Amended Extension Layout

Manchester's Local Care Organisation Technical Officer Service 29 Poland St, Unit 1 Ancoats, Manchester, M4 6AZ	Applicants Name: Miss Juan Maria Jis Property Address: 3 Hartfield Close Brunswick Manchester M13 9YX	REVISIONS - Rev - Wet Room Extended by 1000mm to allow for Shower stretcher to be installed - 02/06/2023	Date: 26/06/2023 Paper Size: A3 Scale: 1:50 Drawn By: Brian Taylor	 Manchester Equipment & Adaptations Partnership
--	---	---	---	---

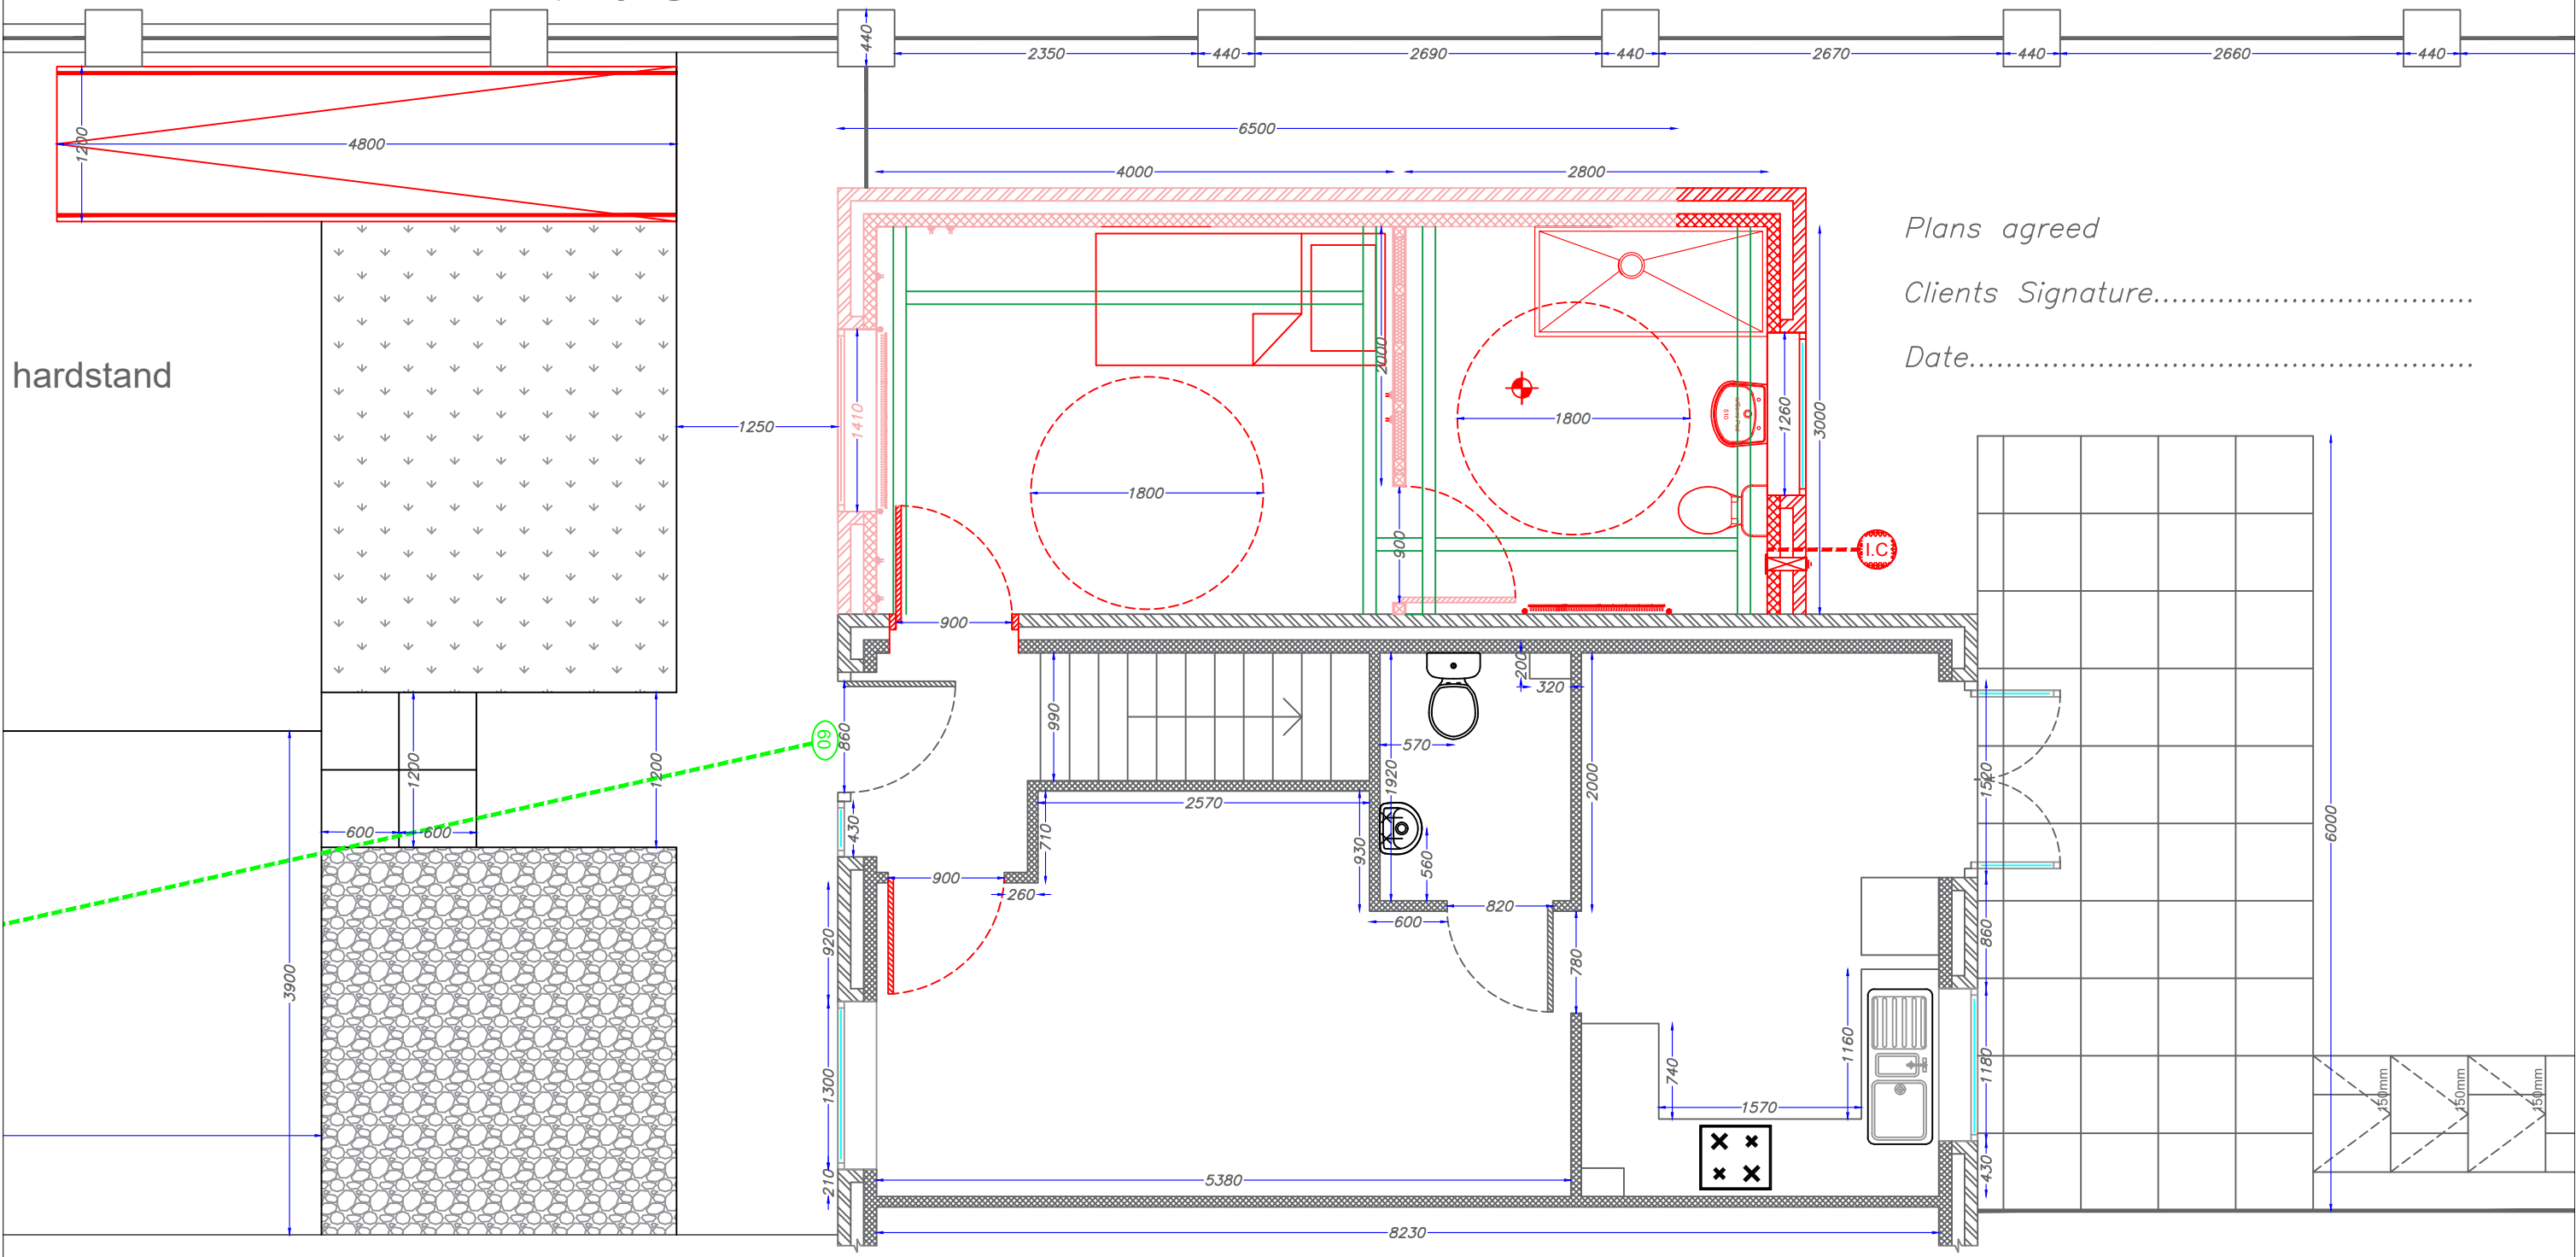
The height difference between threshold and footpath is
460mm - 60mm = 400mm therefore the ramp length @ 1:12 = 4800MM
